REVOLUTION

Service Information Letter #020597

Subject: Mini-500 Airframe Modification

Applicability: All Mini-500's shipped before September 18, 1996

Fig. 1

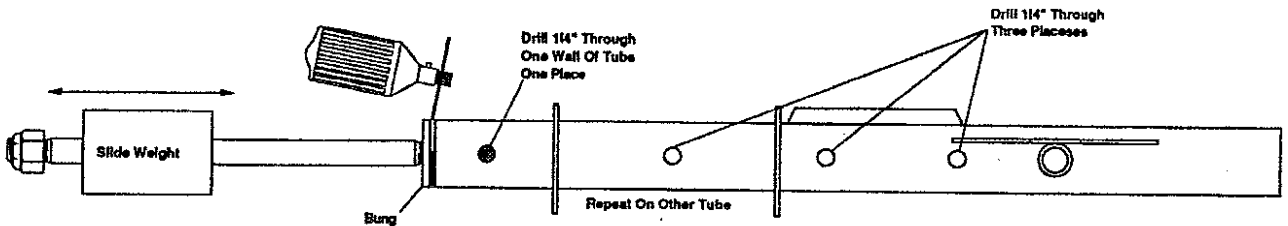
At the request of some customers, RHCI has made available an upgrade kit that would give added strength to this area by increasing the tube wall thickness. The upgrade can be accomplished by following the directions in Figure 1 and Figure 2, by installing an insert tube inside each side of the frame and welding it in place.

- Carefully cut the welded area off of the threaded insert to detach it from the 1" tube. A rotary tool with abrasive cutting wheel is recommended. Try not to damage the tube or threaded insert. After the weld is cut, it may be necessary to use a long bolt or all-thread with a slide weight, and gently tap the threaded insert off of the 1" tube as shown in Figure 1.

3. Drill 1/4" holes in four places per tube as shown in Figure 1. Three of the holes go all the way through the tube and one only goes through one side of the tube.

6. Tig weld the threaded inserts to the 1" tube, and then Tig weld all fourteen (14) holes, joining the insert tube to the 1" tube. Grind the weld on the holes smooth, stress relieve and repaint.

Fig. 2

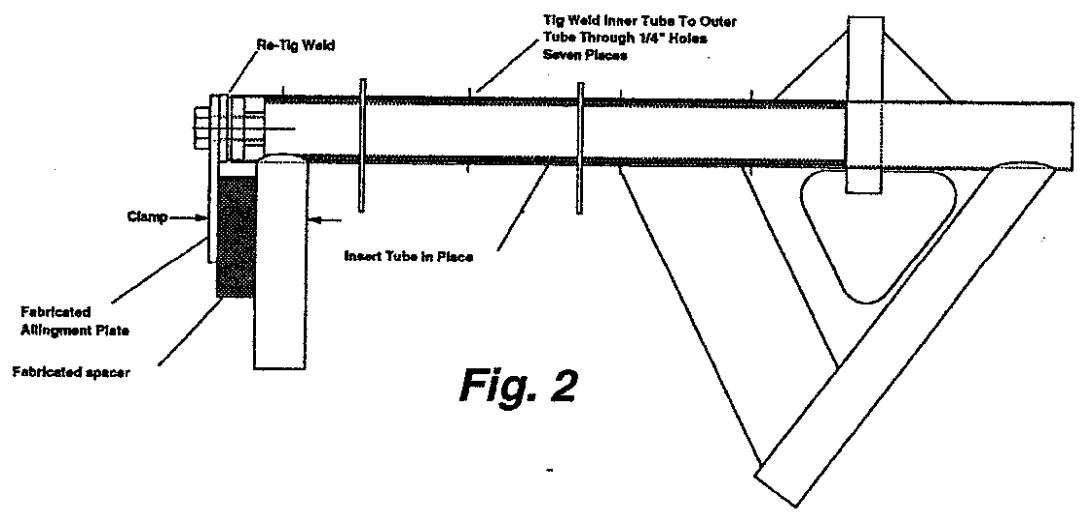
1. Fabricate a plate from 1/8" steel or aluminum as shown in Figure 3.
 2. Fabricate a wooden spacer to fit the gap between the plate and the vertical frame tube as shown in Figure 2. This will be used to relocate the threaded inserts and to prevent the frame from deforming during welding.

5. After insert tube is installed, bolt the threaded inserts onto the fabricated plate. Use a "C" clamp to secure the plate, wooden spacer and threaded inserts into the original location on the frame as shown in Figure 2.
